MEMORANDUM FOR: RECORD

**SUBJECT:** VOLUME REVISION FOR THE PORT OF EVERETT MARINA MAINTENANCE DREDGING – PHASE I, FOR UNCONFINED OPEN-WATER DISPOSAL AT THE PORT GARDNER DMMP SITE.

**PORT OF EVERETT**  
MARINA MAINTENANCE DREDGING PHASE 1  
COMPARISON  
2008 TO 2011 SURVEY

USACE  
David Fox, DMMO  
P O Box 3755  
Seattle, WA 98124-3755  
RE: Port of Everett Marina Maintenance Dredging- Phase I

| DWG. NO.<br><b>FIGURE 1</b> |

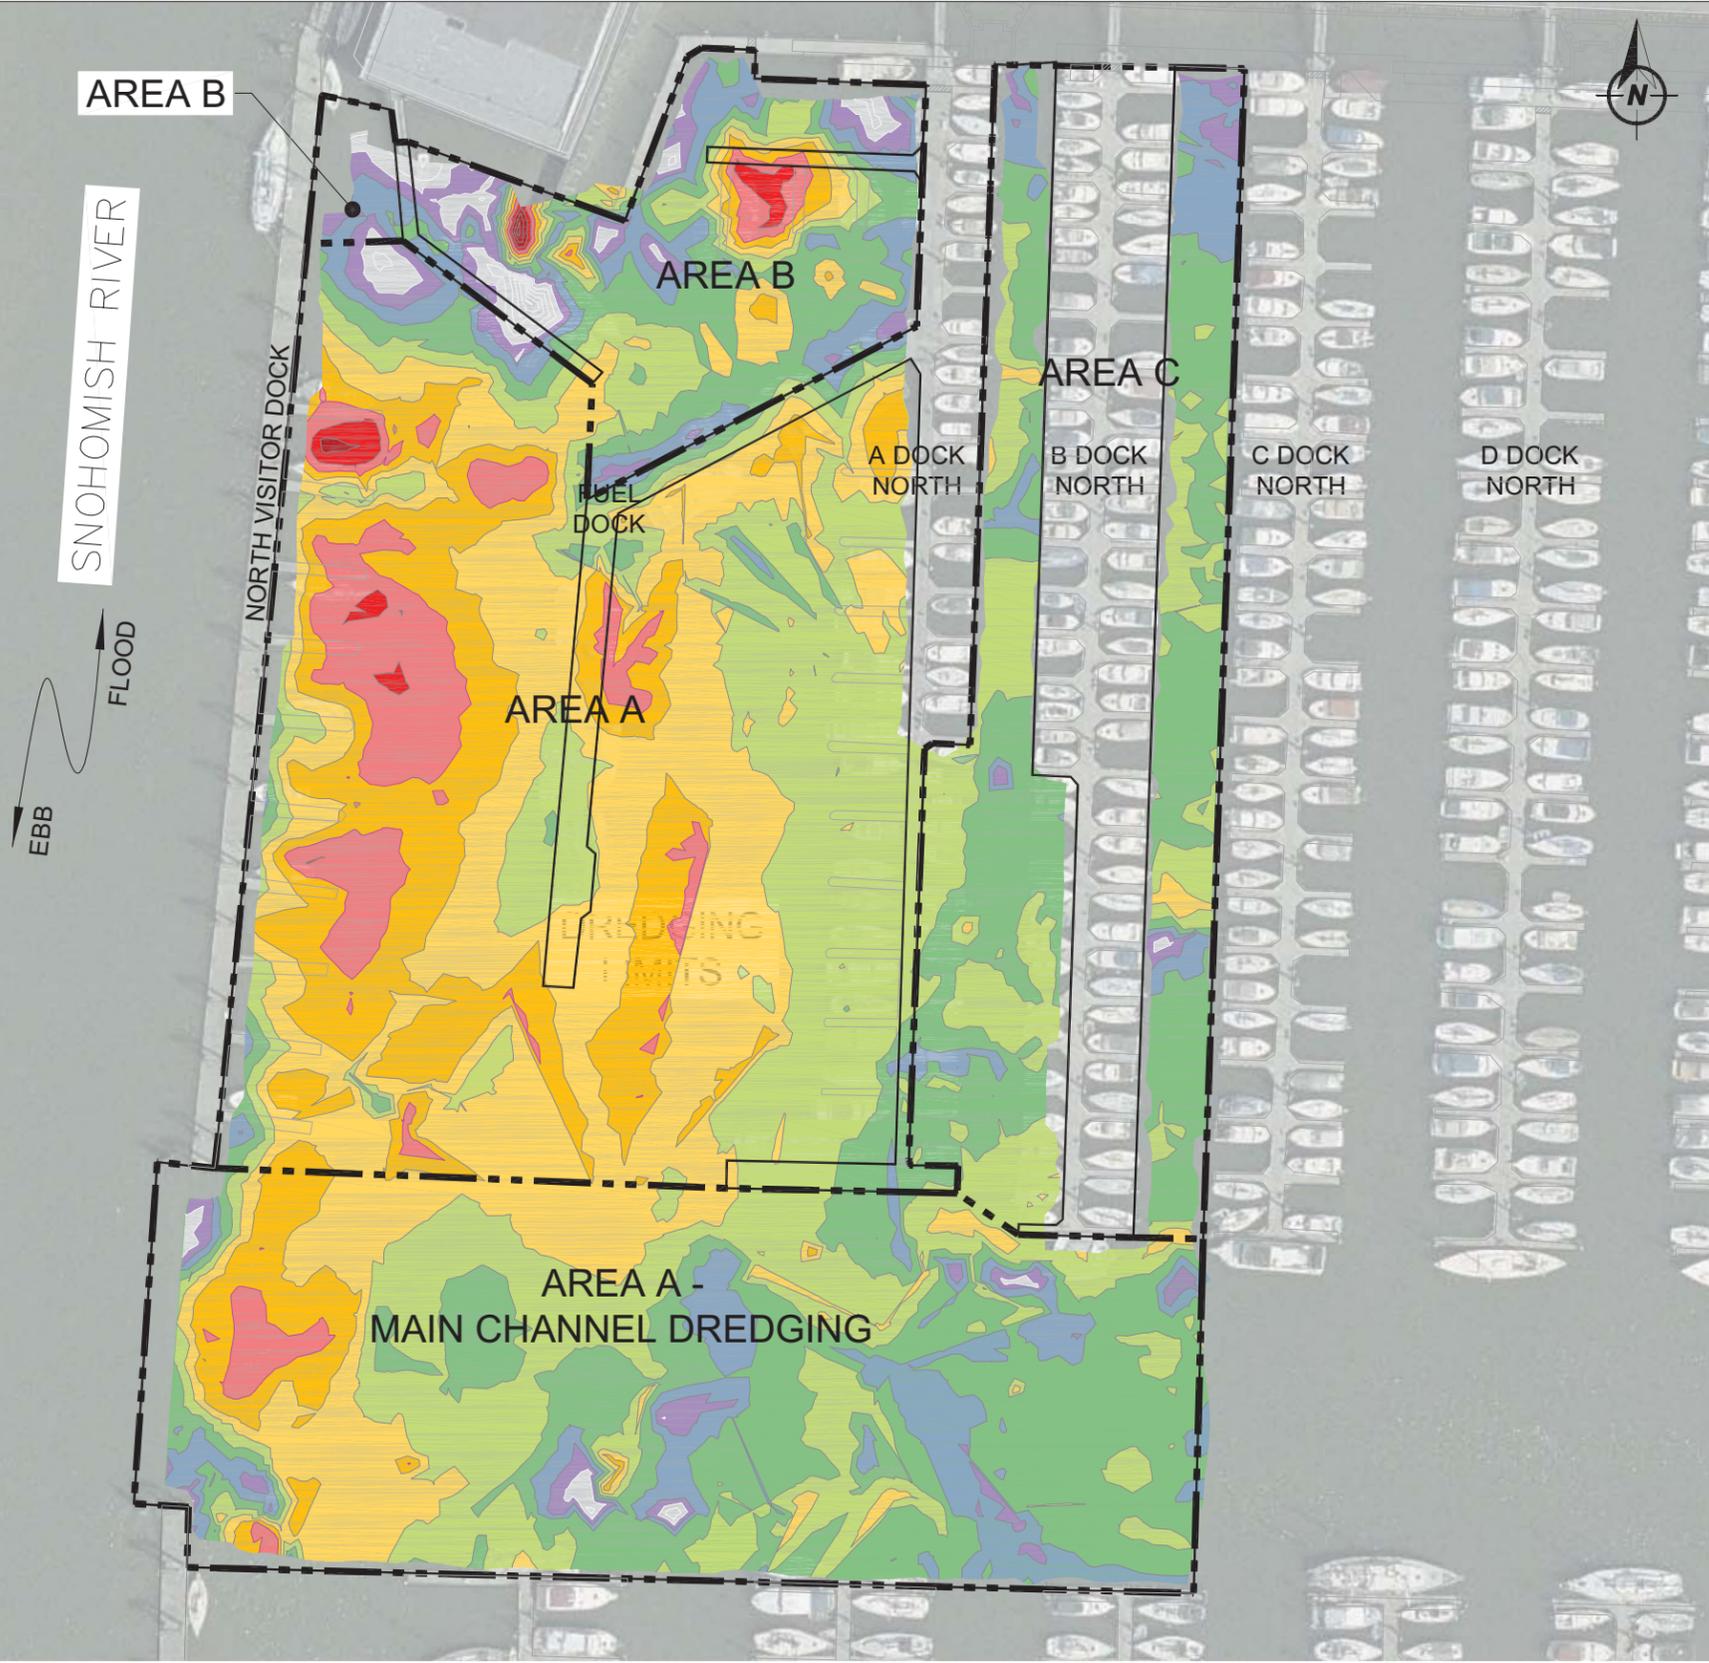
2. The original volume for DMMU 1 of 29,000 cubic yards was based on bathymetry conducted in 2008. Prior to the commencement of dredging in December 2011 a predredge survey was performed. It was determined that significant additional accretion of sediment had occurred in the intervening time. An isopach showing the difference in mudline elevations between the 2008 and 2011 surveys is shown in Figure 1. As can be seen from the isopach, the greatest amount of infilling occurred on the west and north sides of DMMU 1. It is highly likely that this infill consists of clean sediment from the Snohomish River.

The Port requests that the dredging volume for the existing permits and authorizations be amended from the current maximum of 29,000 CY to allow up to a maximum of 39,500 CY for the Phase I Marina Dredging project.

The Port of Everett is currently conducting maintenance dredging in it's marina under the above-referenced permits and authorizations. As was documented in the recent agency email correspondence, which culminated in David Fox's email on Tuesday, January 10<sup>th</sup> (attached), the dredging project design was based on a 2008 condition survey. This was not unreasonable, given that the marina had not been dredged since 2001 and as a result any infill was not anticipated to be significant. However, the pre-dredge survey shows a 90% increase in dredge volumes. An isopach comparison of the design and pre-dredge surveys shows that the infill material appears to be coming from the Snohomish River, as the greatest infill volume is located at the marina entrance and east of the floating visitors' dock that separates the marina from the river. The infill volume decreases toward the east as you get further away from the river.

1. This memorandum supplements the 13 April 2011 suitability determination and reflects the consensus decision on the part of the Dredged Material Management Program (DMMP) agencies (U.S. Army Corps of Engineers, Washington Departments of Ecology and Natural Resources, and the Environmental Protection Agency) regarding a proposed volume increase for the Phase I dredging (DMMU 1) from 29,000 cubic yards (cy) to 39,500 cy.

3. The Port of Everett submitted a request on January 13, 2012 for a volume increase to 39,500 cy for the Phase I dredging (see Attachment 1). Based on the sedimentation pattern; the likelihood that the recently accreted material came straight from the Snohomish River; and past testing of sediment in the Snohomish River navigation channel, the DMMP agencies determined that there is little likelihood that the quality of the newly accreted sediment is an issue. Therefore, the agencies agree that the requested volume increase is permissible without additional sampling and testing.
